## Parts Bulletin

Group	Number	Version
P-44-1	8	01

### Shift mechanism, shift cone & shoe

Models: Sterndrives, Saildrives, Inboards

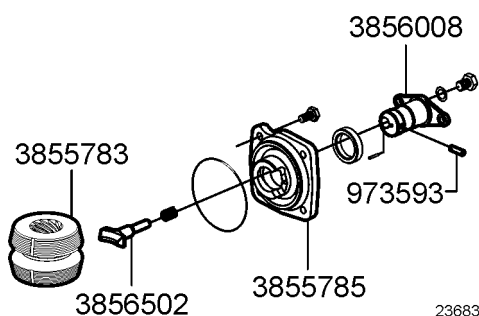
The shift cones (sliding sleeves) listed in earlier catalogs have been replaced by an improved shift cone, 3855783. When using this new cone to repair earlier drives or transmissions, you must use new shift shoe 3856502 with the new cone. Do not use the shift shoe mated to the original cone or shown with the original cone in the catalogs.

**Note!** Use of these earlier shoes with the new cone could damage the cone. It may also cause poor shifting.

The improved cone and shoe were part of a group of new parts released to improve shifting. The new parts are shown in the diagram.

These newer parts replace many earlier shift parts. In most cases the earlier part is replaced by more than one of the newer parts. Always use all of the new parts specified in the replacement. The newer parts are designed to work together and can not be mixed with the older parts.

Earlier cones affected by this change are replaced in the parts systems. If an earlier cone is ordered the system will replace it with a new cone and new shoe.

The parts not listed in the illustration are the same for the newer and earlier versions of the shift mechanism.
